TE Connectivity

Product Change Notification: E-14-009314

General Product Description:
 Superseal 1.5 series connector.

Product image before change

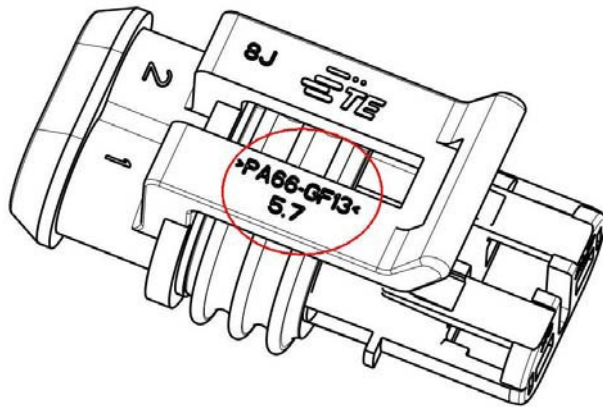
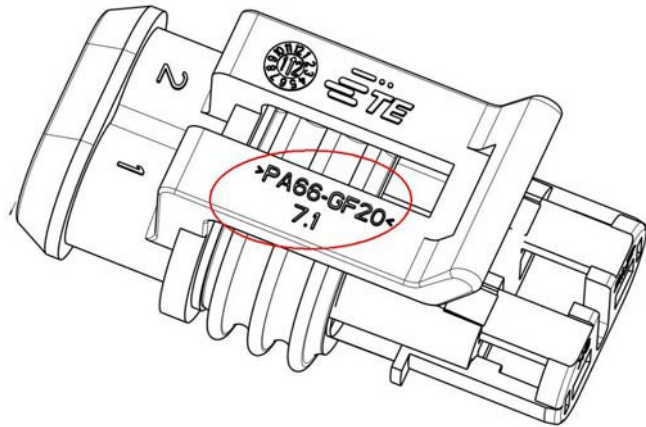
Material change. This change is considered by TE Connectivity as an improvement. Location of change, see material logo.

Product Improvement. PA66 20% GF material has to be replace the actual one (PA66 13% GF).
